Response to the Referee

Referee #1

The manuscript describes an updated version of the Building Energy Model coupled to SLUCM. The new model is tested against a series of indoor temperature data in London and building energy consumption in Tokyo.

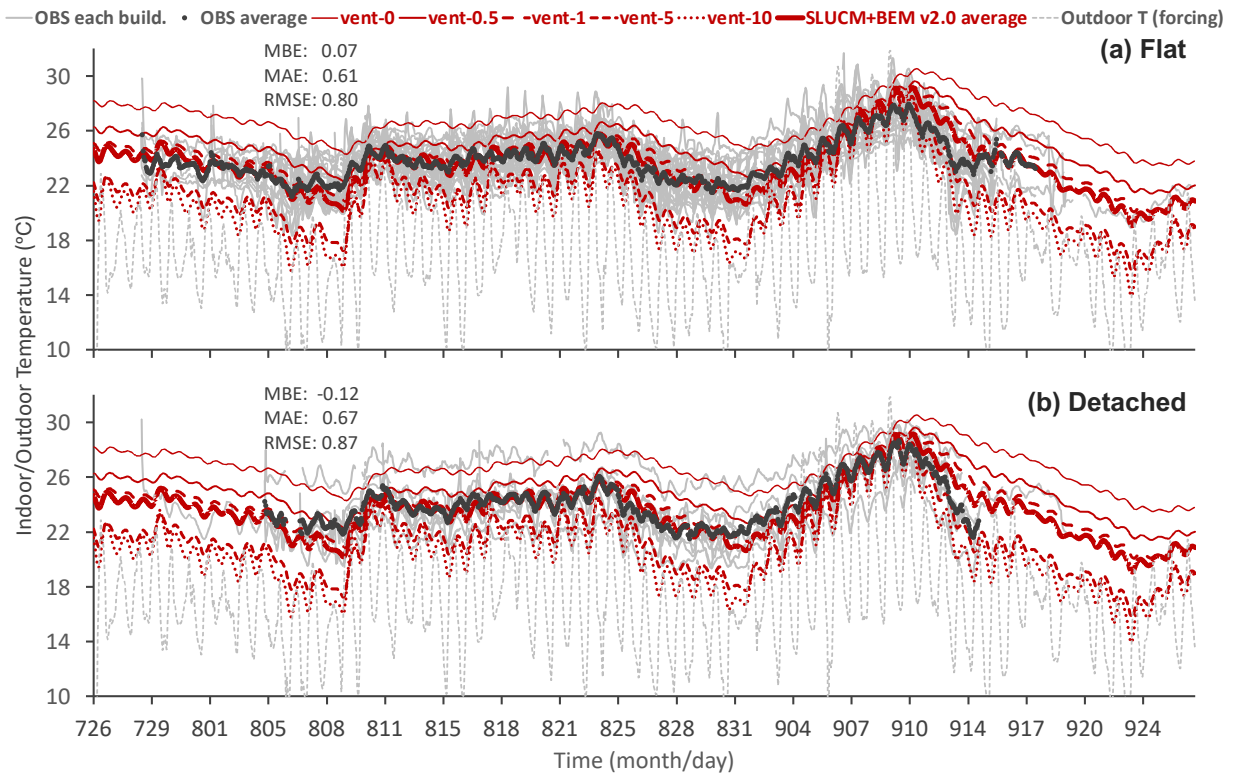
Lines 329. Is vent-10 equal to vent-rate=10 (of Eqn. 19)?

4. I know there are already many lines, but knowing the value of the outdoor air temperature would help in the interpretation.

Yes. We clarified this in the text and figure caption. The label “vent-10” means the sensitivity experiment with $\text{VENT_RATE} = 10 \text{ h}^{-1}$ in Eqs. (19)-(20). In the source code, the corresponding input parameter is named `VENT_FREQ`, so VENT_RATE in the manuscript corresponds to `VENT_FREQ` in `module_sf_urban.F` and `URBPARAM.TBL`.

“The case name vent-X denotes the experiment with $\text{VENT_RATE} = X \text{ h}^{-1}$; for example, vent-10 corresponds to $\text{VENT_RATE} = 10 \text{ h}^{-1}$.”

We agree. To make the interpretation of the indoor-temperature response clearer, we added the outdoor air temperature used to force the offline London simulations to Fig. 4. This allows the reader to compare the observed and simulated indoor-temperature variations directly with the outdoor-temperature forcing.
